UPDATE CHANGE NOTIFICATION # 16361A

TITLE: Ordering Information Update for CAT24C02, 2Kb I2C Serial EEPROM

Top package Marking CAT24C02 (Gresham die based)

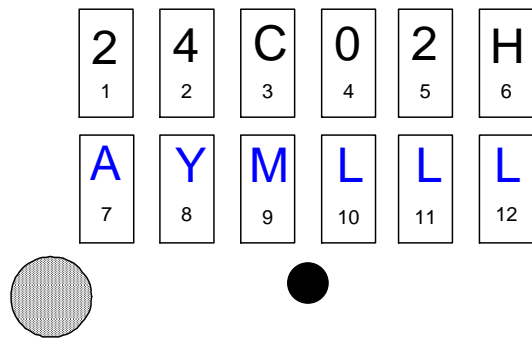
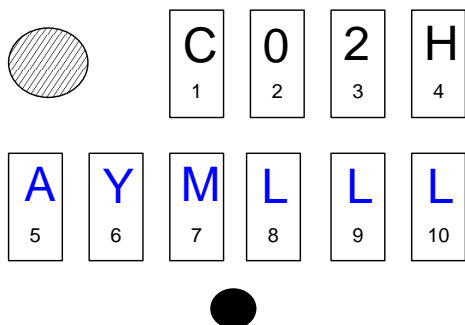
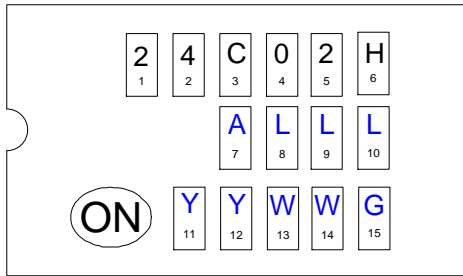
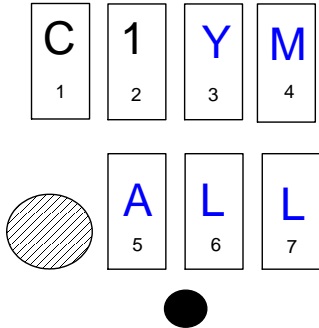
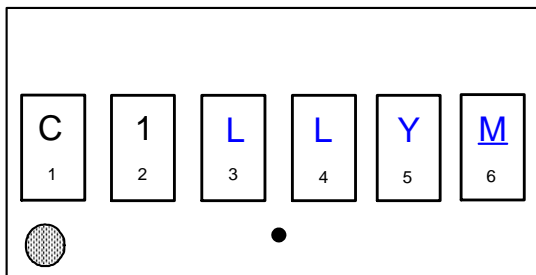
The package marking will follow the actual top package marking used for the CAT24C02 Gresham die based, as shown in the Appendix.
